# Product Change Notification

PCN-20211124.HFX

ABB Cable Management Product Ltd. Will make the changes described below to products within the Harnessflex Cable Protection product range.

**Previous Drawing:**

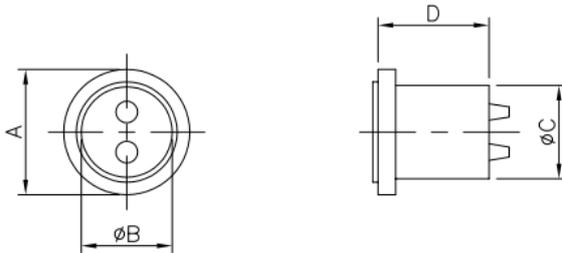
**Product RSG02 now moved to alternative tooling therefore new revision of product; removal of bumps and change of diameter from 18.7 mm to 17.0 mm.**

**New Drawing:**

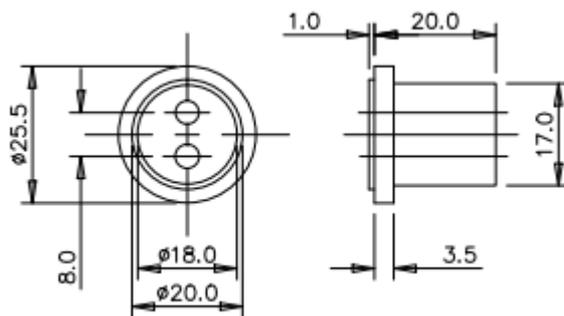
RSG02 ALTERNATIVE TOOLING
